PSE&G Public Service
Electric and Gas
Company

September 26, 1984

HOPE CREEK GENERATING STATION
DOCKET NO. 50-354
DRAFT SAFETY EVALUATION REPORT
OPEN ITEM STATUS

<p>HOPE CREEK GENERATING STATION FINAL SAFETY ANALYSIS REPORT</p>
<p>4.16 KV, 3Ø, 60 Hz NON-SEGREGATED BUS DUCT</p>
<p>FIGURE 8.3-16 AMENDMENT 8, 10/84</p>

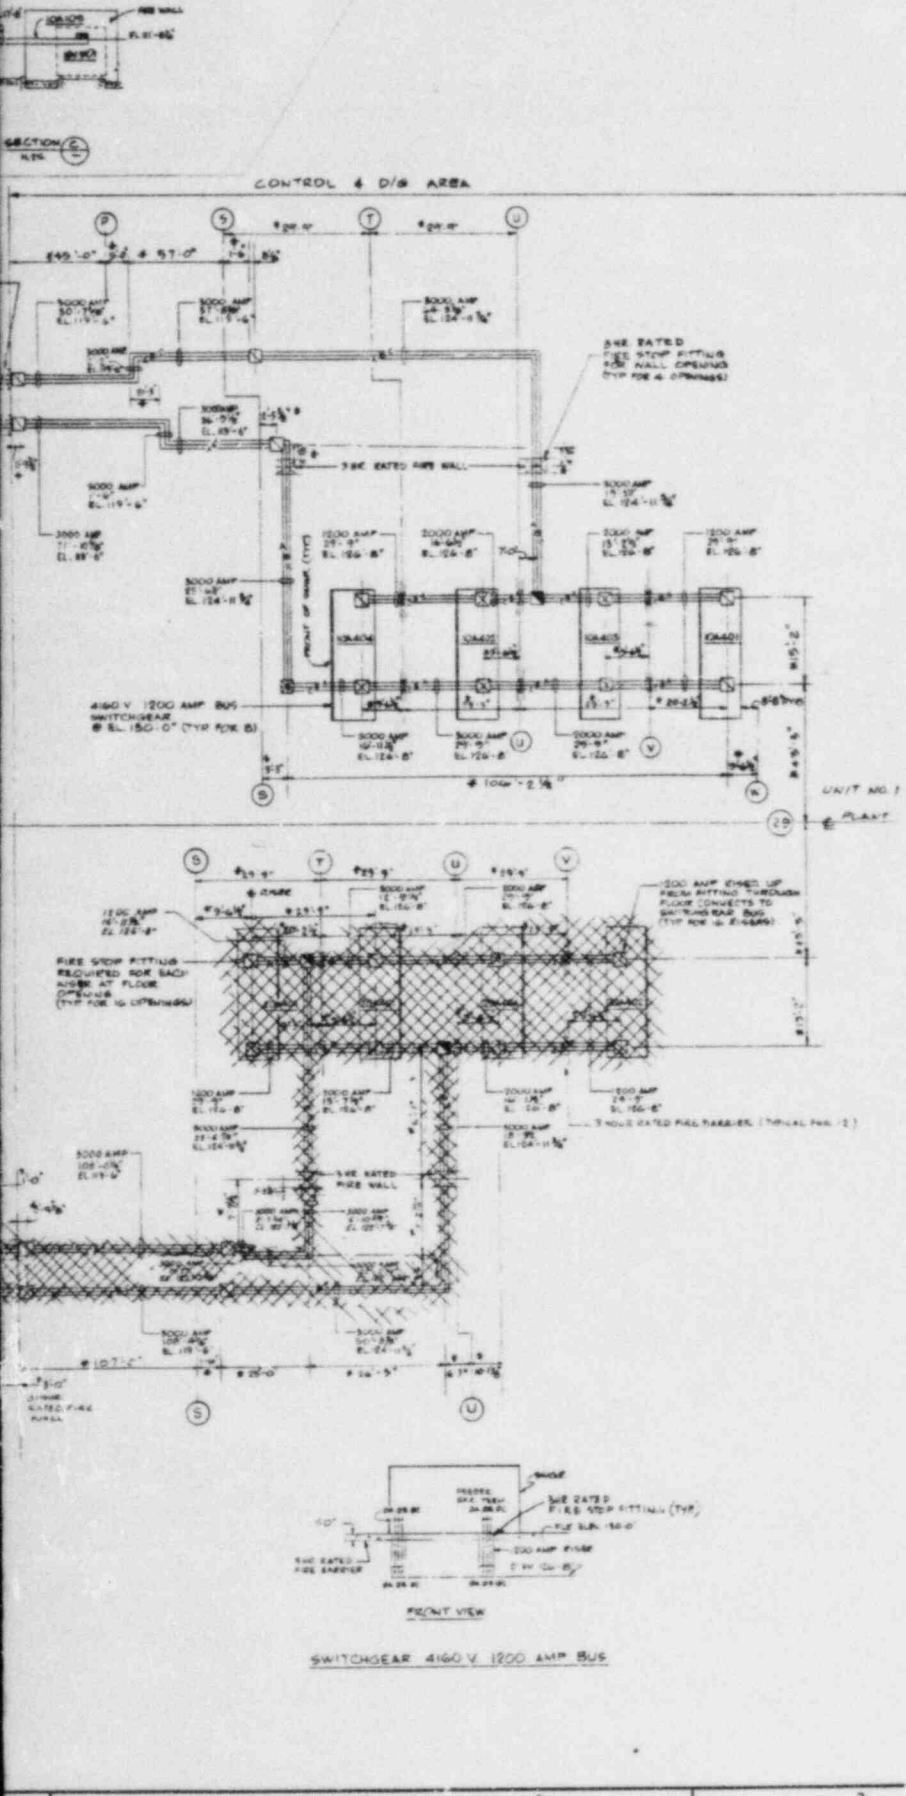
Each of the 4.16 kv Class 1E busses at Hope Creek is supplied power from preferred offsite and standby onsite circuits. It is the staff position that these circuits should not have common failure modes. Physical separation and independence of these circuits has not been described or analyzed in the FSAR. By Amend. 4 to the FSAR, the applicant, in response to a request for information, indicated that a single event can not cause common failure of both onsite and offsite power source circuits because they are separated in accordance with the requirements of Regulatory Guide 1.75. The staff disagrees. Separation in accordance with Regulatory Guide 1.75 by itself is not sufficient for the staff to conclude that there are no common failure modes or to conclude that the probability of coincident loss of both onsite and offsite power sources has been minimized in accordance with the requirements of Criterion 17 of Appendix A to 10 CFR 50.

Each of the 4.16 kV Class 1E busses at Hope Creek is supplied power from preferred offsite and standby onsite circuits. It is the staff position that these circuits should not have common failure modes. Physical separation and independence of these circuits has not been described or analyzed in the FSAR. Provide a description and analysis in accordance with Section 5.2.1(5) of IEEE Standard 308-1974.

Figure 8.3-16 shows the routing of these non-segregated phase bus ducts from station service transformers 1AX501 and 1BX501 to 4.16 kV switchgear.

FSAR Section 8.3.1.2.1 has been revised to include the results of an analysis to show compliance of the onsite and offsite power systems to GDC 17. FSAR Figure 8.3-16 is attached to DSER Open Item 223.

FIGURE 1 - TEST SETUP FOR TRAY-TO-TRAY

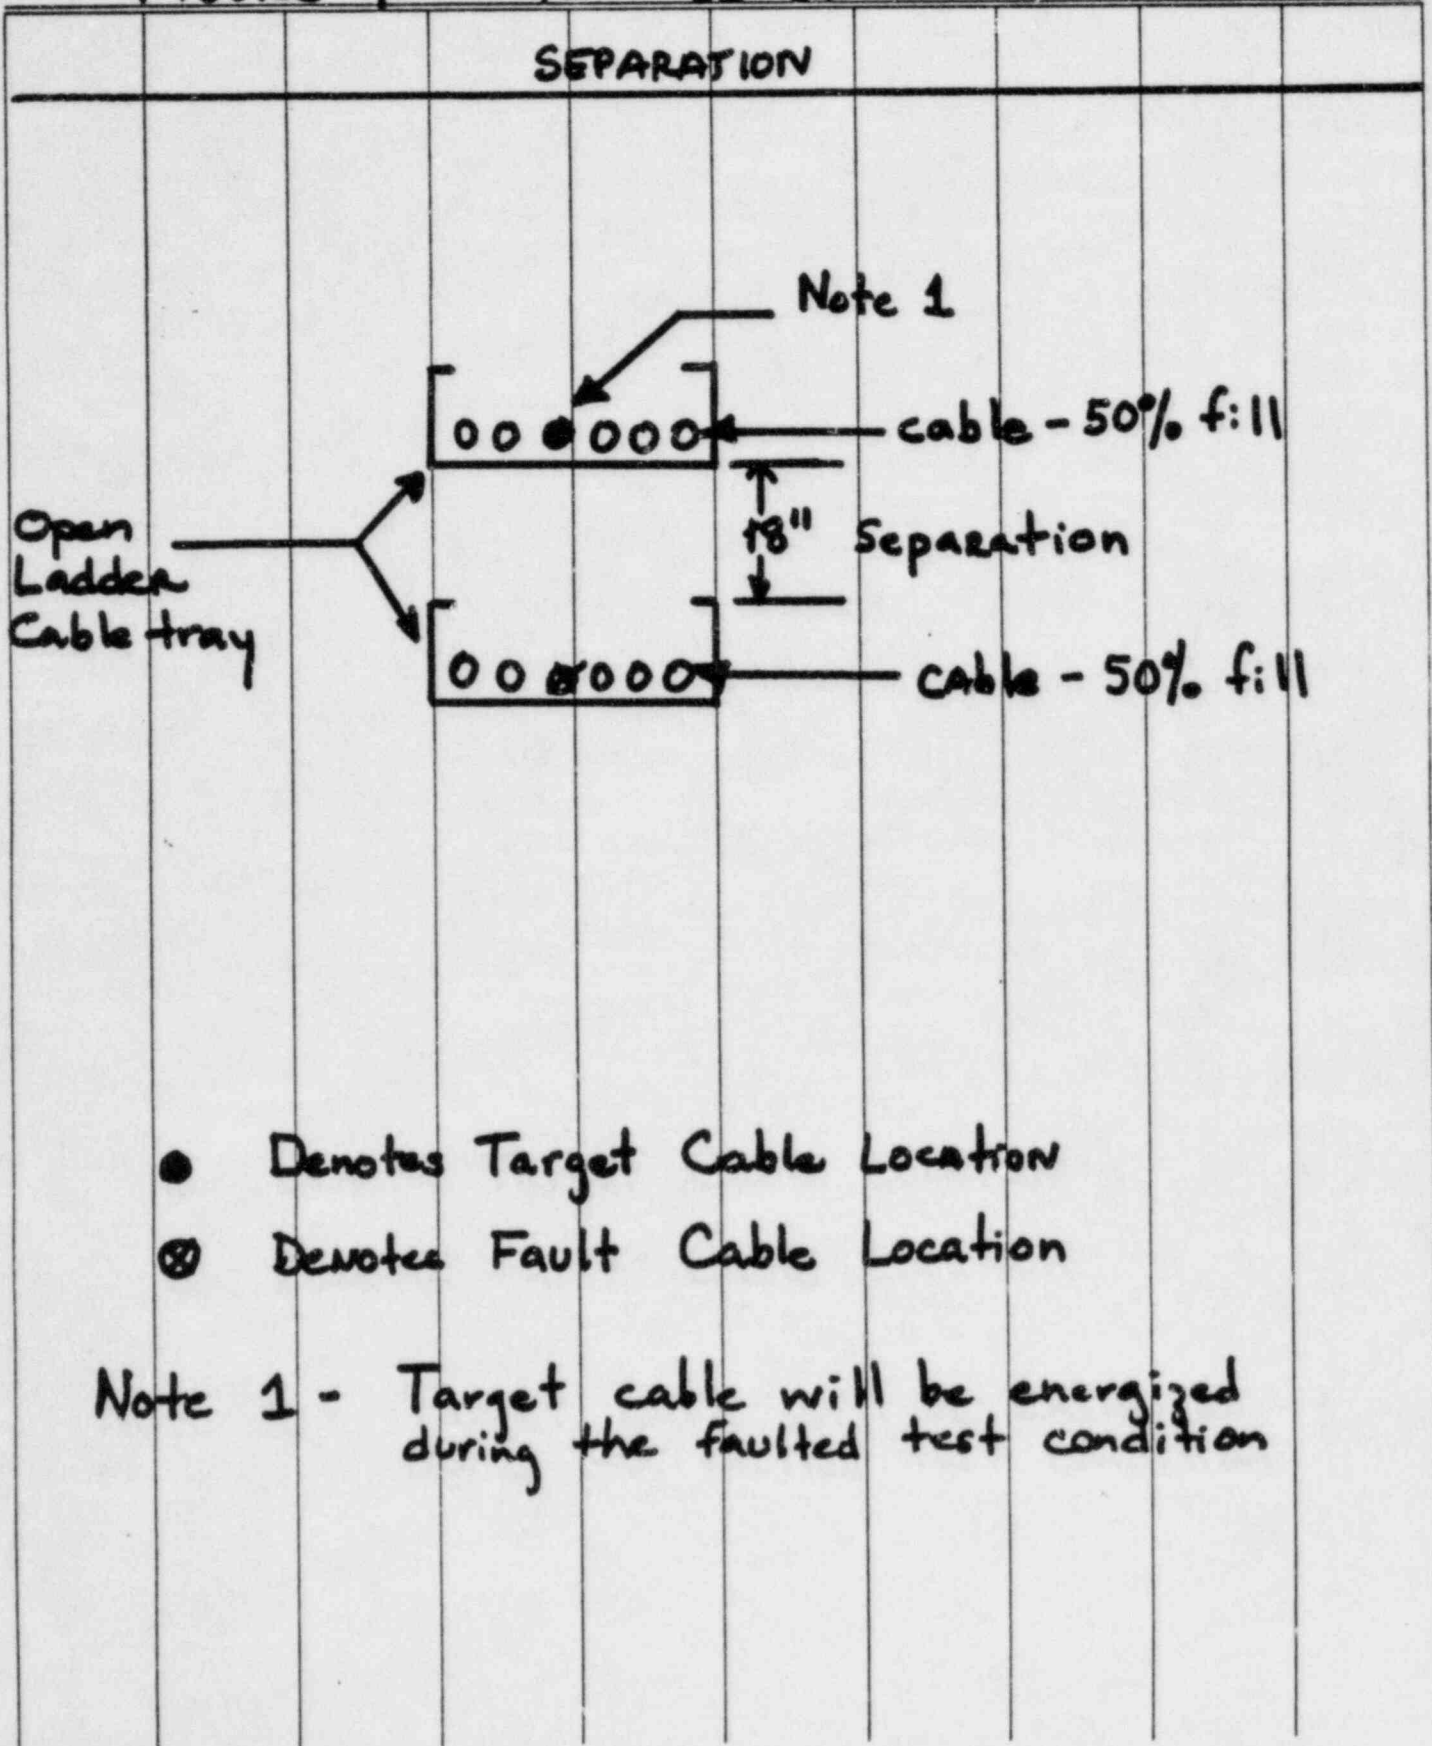
The applicant, by Amendment 4 to the FSAR, indicated that this 18 inches of separation was approved by the staff during the preliminary design review of the Hope Creek plant. The staff's preliminary safety evaluation report for this item states that:

In Sections 1.8.1.75 and 8.1.4.14.3.1 of the FSAR you state that separation between redundant cable trays in the cable spreading area, control equipment room, relay room, and main control room are separated by 18 inches of separation required by IEEE Standard 384-1974. Provide analysis substantiated by test that demonstrates the adequacy of 18 inches of separation.

Revised section 8.1.4.14.3.1 provides the analysis based on this test to demonstrate the adequacy of 18 inches separation.

In addition to the above test, an additional cable tray test will be performed that tests electrical shorting of electrical cabling utilizing the 18 inch vertical separation. This test plan is being submitted under separate cover.

If the test is unsuccessful, then cable tray covers will be added to the trays in accordance with IEEE Std 384-1974.

FIGURE 430.33-1 AMENDMENT 4, 1/84

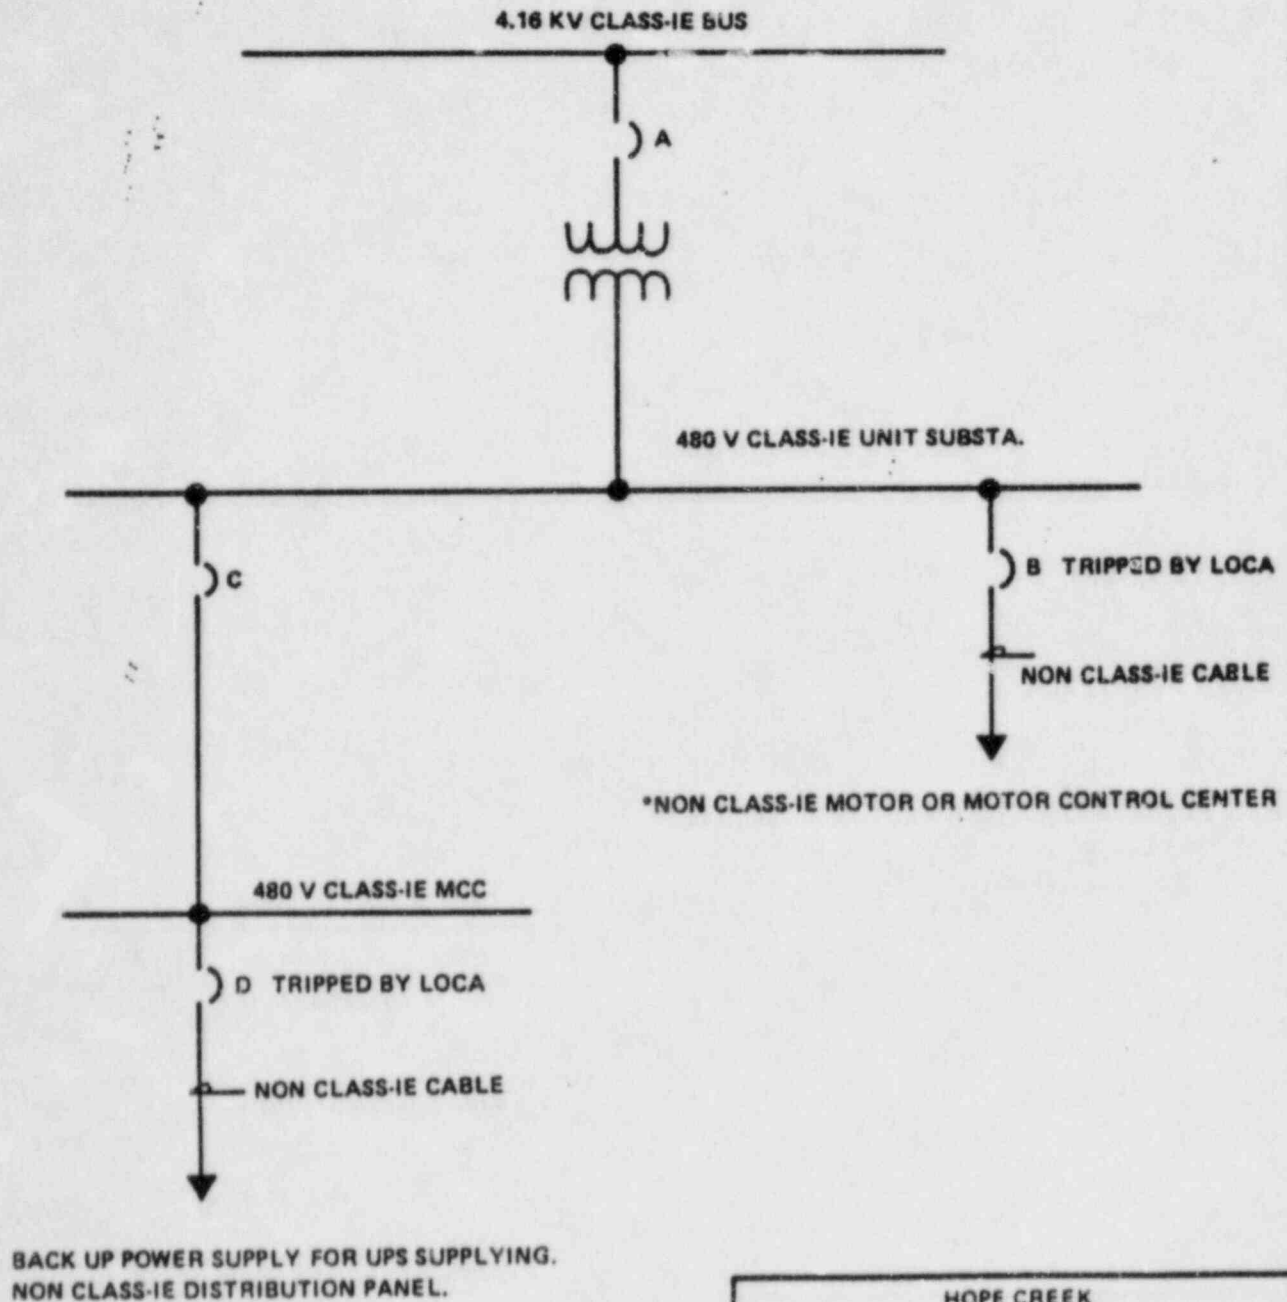
By Amendment 4 to the FSAR, the applicant indicated that the non-Class 1E public address system distribution panel shown on sheet 2 of Figure 8.3-11 of the FSAR is supplied power from the Class 1E dc system through an inverter. The applicant further stated that this inverter is an acceptable isolation device per IEEE-384-1981, Section 7.1.2.3. The staff does not agree. Test and analysis to demonstrate the adequacy of an inverter as an isolation device will be pursued with the applicant.

The response to Question 430.33 has been revised to state that the inverter will be tested as an isolation device. In the event that the tests are not successful, the non Class 1E loads will be removed or the cables will be re-routed.

Figure 430.33-1 shows the two configurations that employ a circuit breaker tripped by a LOCA signal as an isolation device. The two configurations are:

Protective device coordination studies for devices shown in Figure 430.33-1 have shown that the time-overcurrent trip characteristics of circuit breakers A, B, C, and D are such that:

Periodic testing of the breaker time-overcurrent trip characteristics will be performed to demonstrate that the circuit breaker trip function remains within required limits. Table 430.33-1 identifies the non-Class 1E loads that are supplied through circuit breakers B and D of Figure 430.33-1.
